SUBJECT: TECHNICAL REVIEW OF "TANK 16H SPECIAL ANALYSIS FOR THE
PERFORMANCE ASSESSMENT FOR THE H-TANK FARM AT THE
SAVANNAH RIVER SITE", SRR-CWDA-2014-00106, REV. 1,
FEBRUARY 2015 (DOCKET NO. PROJ0734)

Technical Review of Special Analysis for Tank 16H

SRR-CWDA-2014-00106, Revision 1, "Tank 16 Special Analysis for the Performance Assessment for the H-Tank Farm at the Savannah River Site", Savannah River Remediation, LLC, Closure and Waste Disposal authority, Aiken, South Carolina, February 2015.

Figure 3. Water movement through grouted tank system under constant and fluctuating water table scenarios (adapted from SRR-CWDA-2014-00106)

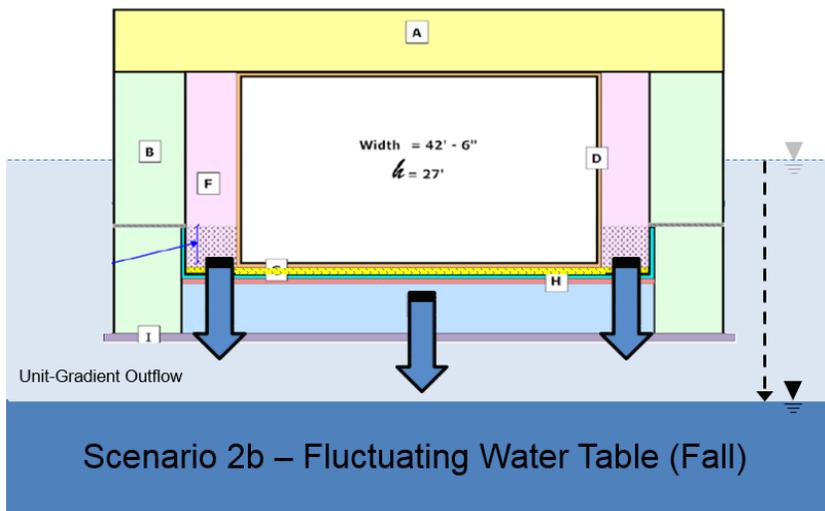
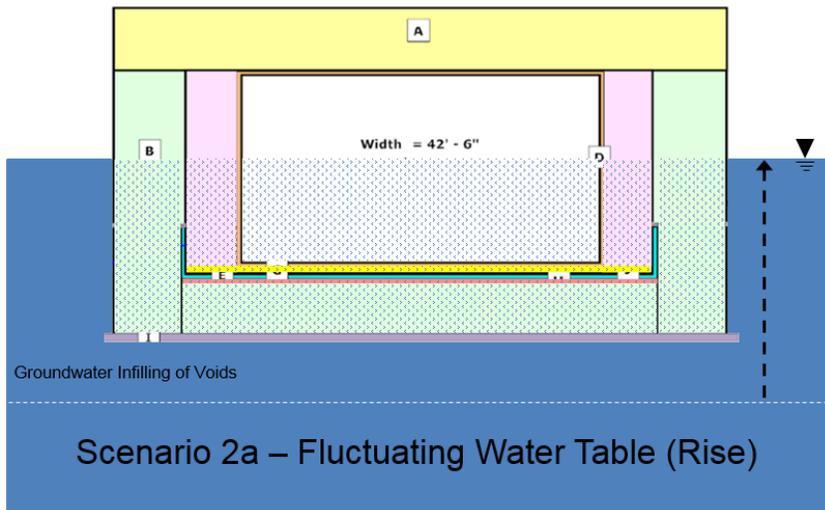
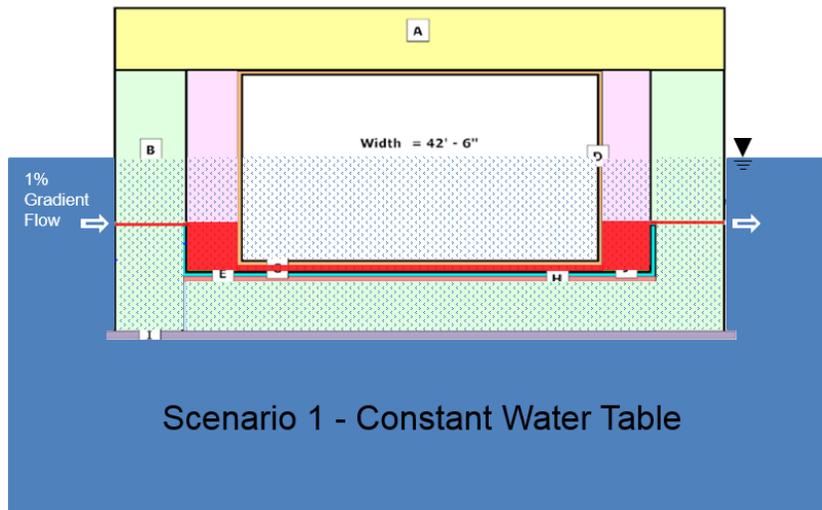
The assumption that the annulus grout is a significant flow barrier is problematic in this sensitivity case. NRC staff intended for DOE to run a case with a preferential pathway through the entire tank system, and not simulate a low conductivity grout that restricts flow in the preferential pathway through the annulus. Unless it can be demonstrated that shrinkage or cracking will not occur in the grout annulus, NRC staff continues to recommend that DOE evaluate radionuclide release from the annulus and sand pads with a continuous preferential pathway. Secondly, DOE assumes that the fast pathway is saturated with a 1% hydraulic gradient between the most upgradient and downgradient portions of the tank system (see Figure 3, Scenario 1). In the July 28-29, 2015, Onsite Observation Visit (ML15239A628), NRC staff reiterated their concern of the risk associated with the potential rise and fall of the water table. NRC staff thinks that the rise and fall of the water table is likely to be more risk significant for radionuclide release from the annulus than under a saturated flow condition. A rise and fall of the water table could be simulated with a unit hydraulic gradient (versus 0.01) and likely corresponds to a greater volume of water contacting the residual waste in the annulus (see

Figure 3, Scenarios 2a and 2b). If the possibility of this scenario cannot be excluded, it should be evaluated by DOE. In addition, the basis for the 1% hydraulic gradient to represent the potential across the resistive engineered barrier is not clear. If DOE relies on the AFZ analysis with the 1% hydraulic gradient, additional information should be provided to support this value. Lastly, the inventories of long-lived radionuclides (e.g., Pu-239, Np-237) are potentially risk significant and should be included in the AFZ analysis. Based on these limitations of the AFZ analysis, NRC staff concludes that DOE's Tank 16H Special Analysis does not adequately evaluate the potential risk associated with the Tank 16H annulus and sand pads. To address this technical issue, DOE could run additional simulations that consider the essential elements listed in the bullets above (e.g., consideration of shrinkage gaps, rise and fall of the water table, and long-lived radionuclides).
